ADDENDUM NO. 4

PROJECT: Garvin Building Hazardous Material Abatement & Renovation Floors 3, 4, & 5

ADDENDUM #01

Building 75 – Garvin Building Hazardous Material Abatement & Renovation Floors 3, 4, & 5
425 Robinson Street
Binghamton, NY 14224

A114D

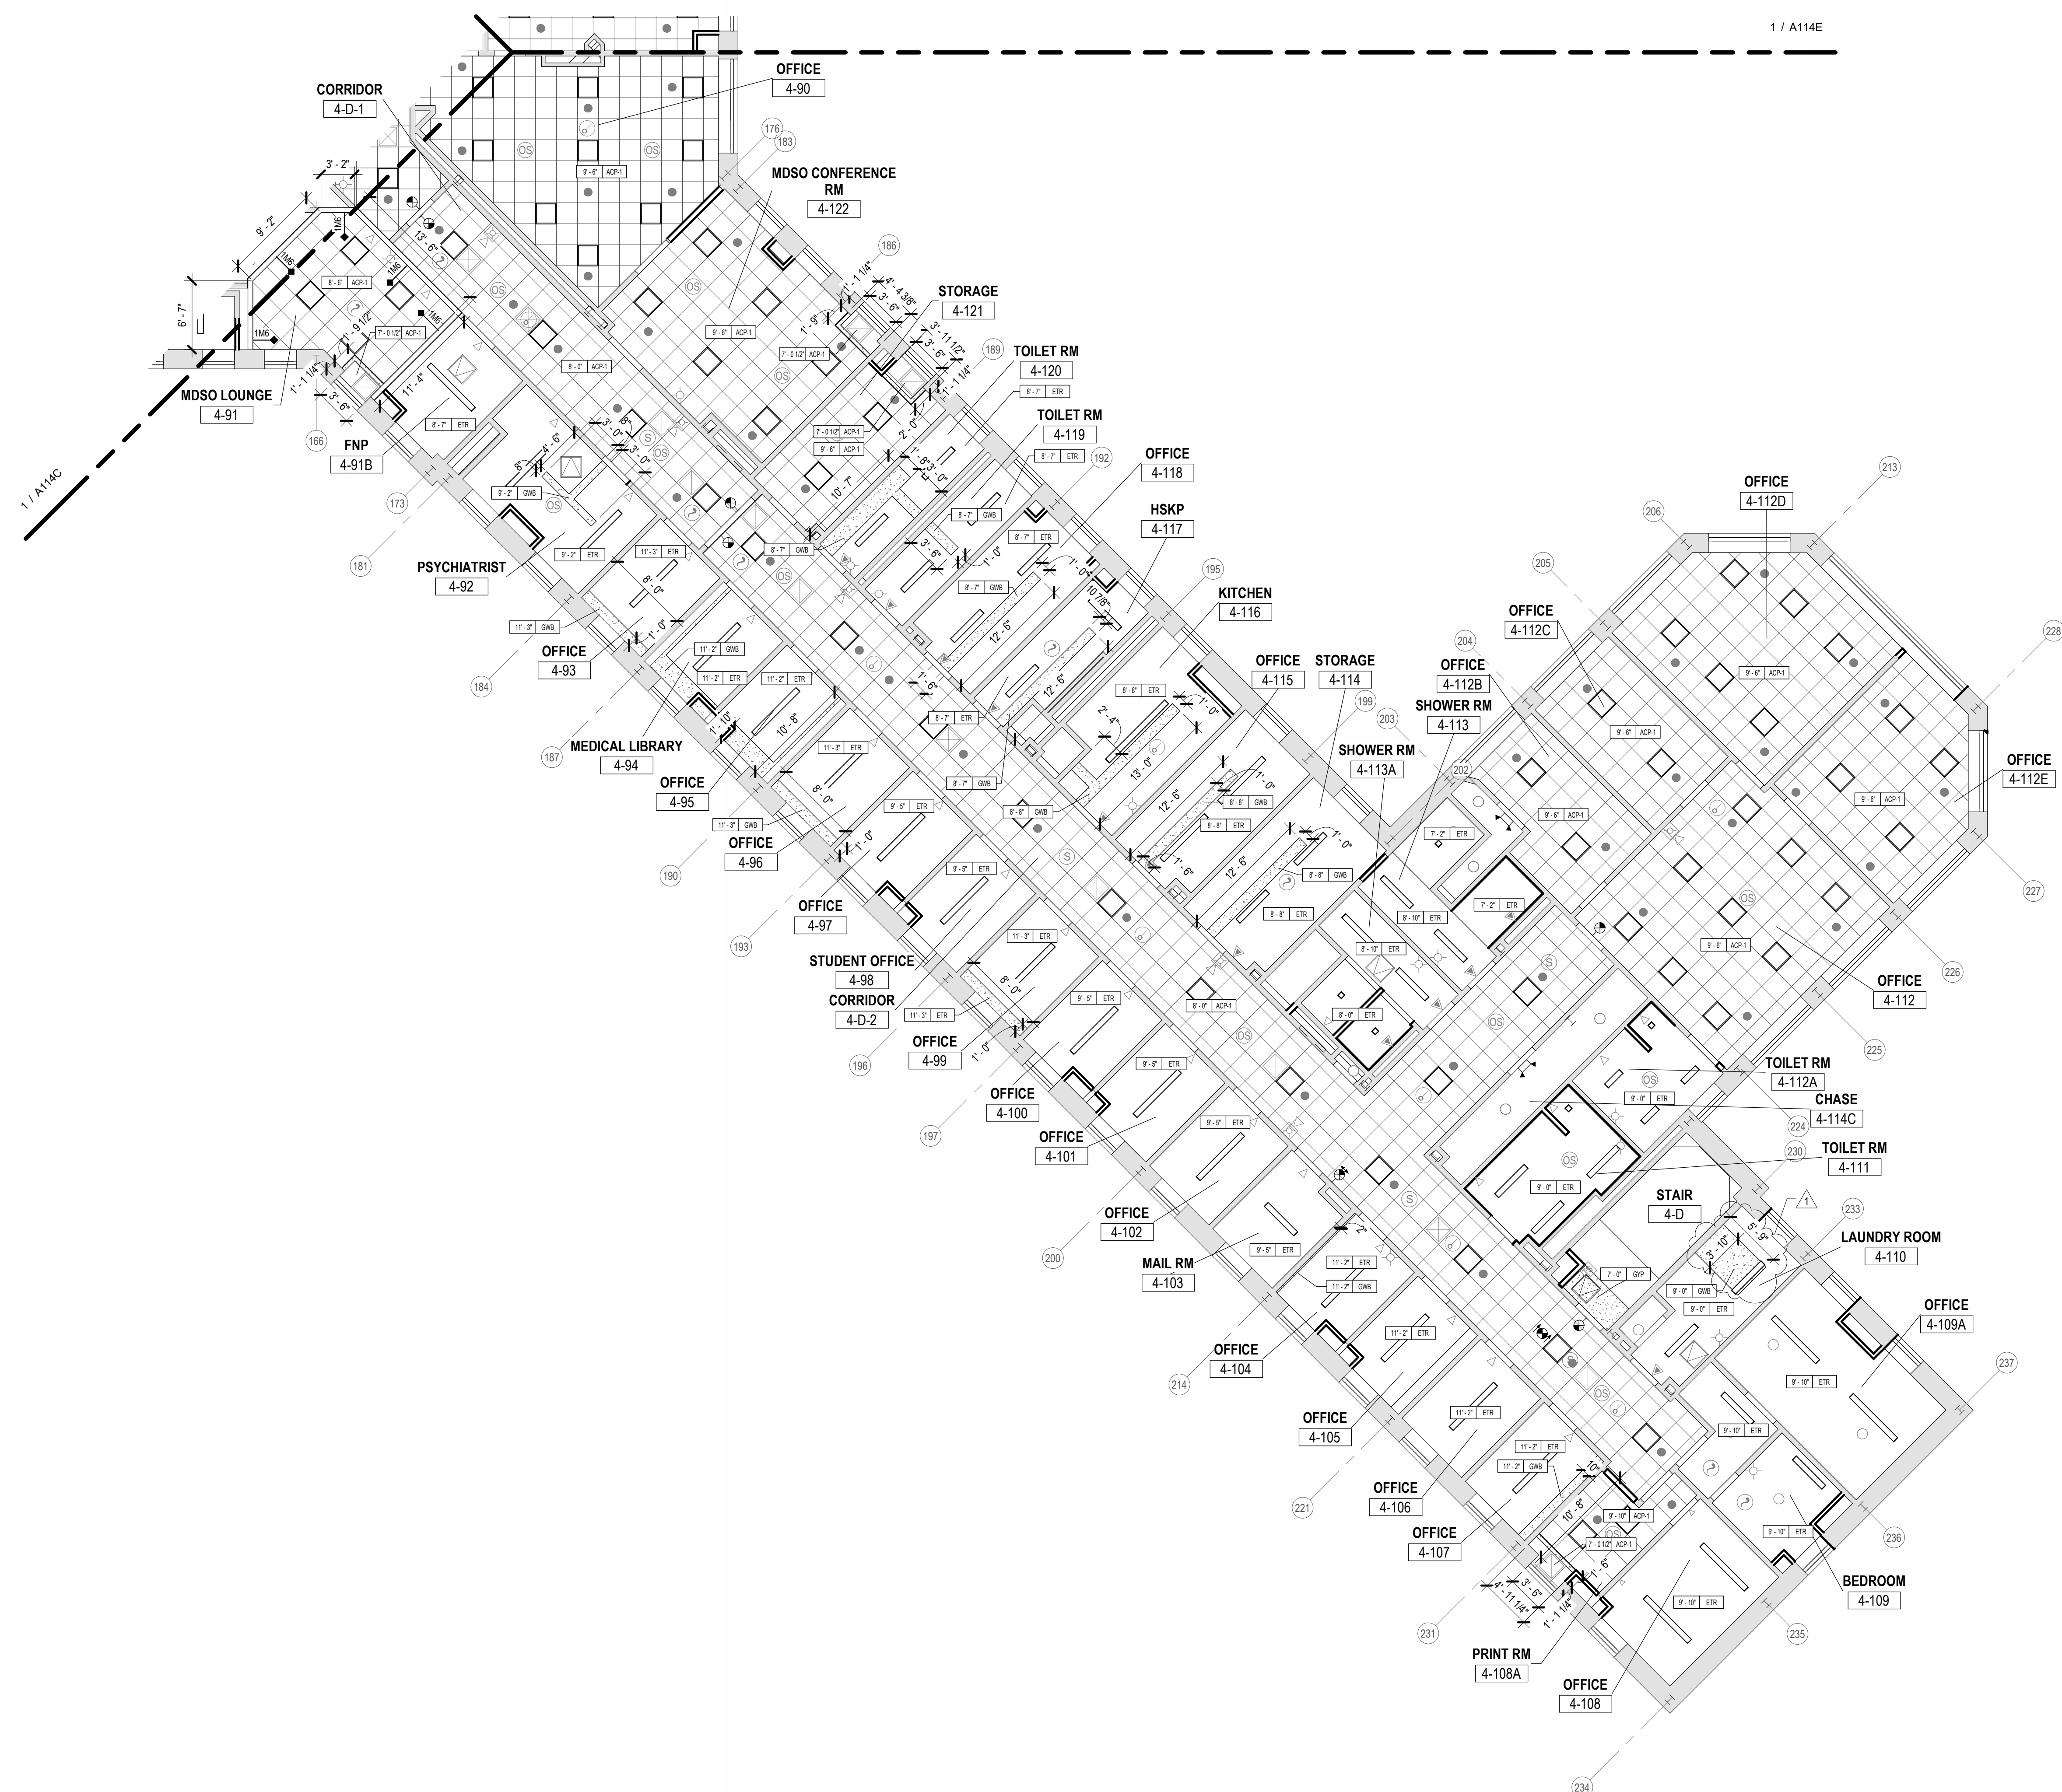
- g) AD201B – Exterior Elevations Removal: **REVISE** detail 3/AD201B to change the window of Wing 3A to be existing to remain.
- h) A114D – Partial Ceiling Plan – 4th Floor – Wing D: **REVISE** Laundry Room 4-110's ceiling alteration portion to be 3' – 10" wide by 5' – 9" long.
